**ON-SITE SEWAGE DISPOSAL SYSTEM
 HOWARD COUNTY HEALTH DEPARTMENT
 BUREAU OF ENVIRONMENTAL HEALTH**

RE: File Number: F-07-023
Robert Moxley Property
3686 Folly Quarter Road

The Department of Health completed the review of the Robert Moxley Property final plan. The revisions/ corrections mentioned below must be corrected prior to plan approval or signature. Applicant is advised to revise and resubmit prior to signature.

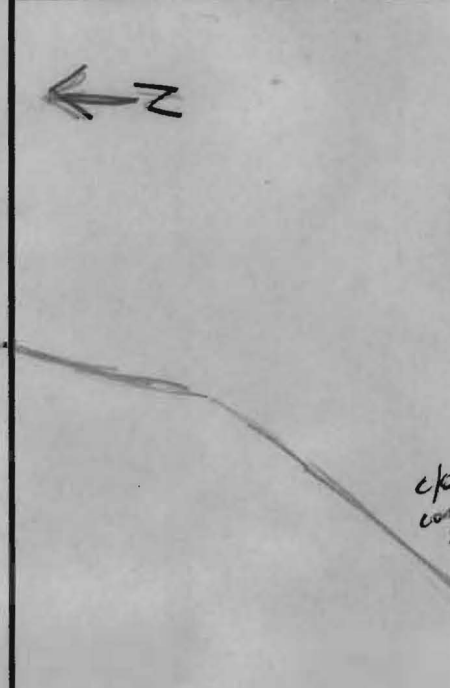
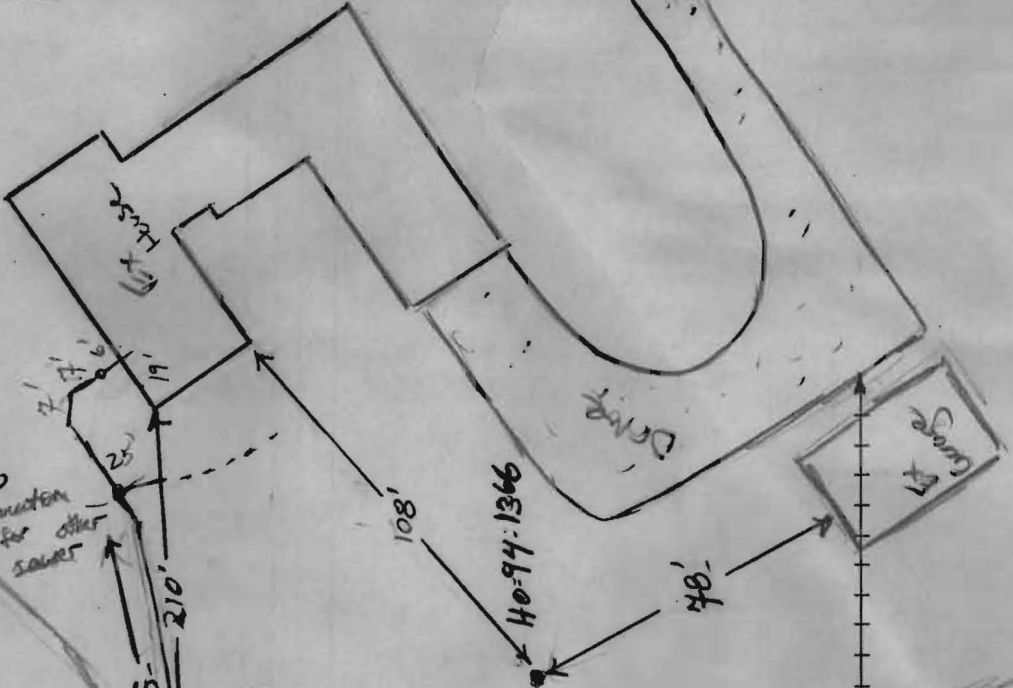
Due to depth of base connection, contractor tried to move tank away from house. Contractor was hitting rock @ depths 3' - 5'. Had hard time finding area w/ a 25' easement between F.L. area to place S.T. (KW)

PRE-CONSTRUCTION 9/19/07 Keep S.T. 20' from house and 100' from well. Install 4 trenches on contour totaling 280'.

INSTALLATION as possible. 2 x 60' running to one side of S.D. and 2 x 77' if possible. 9/20/07 Top trench dig, stored.

Additional septic stone w/ dot of lime. Told contractor 2 ft ports, stone will not be approved. (KW)

9/21/07 Second 45' trench finished. Ran a little close @ end of trench to go above huge pop oak tree. House connection extending 7' + below grade caused us to move tank 200' + down hill towards septic area. OK to continue (KW)
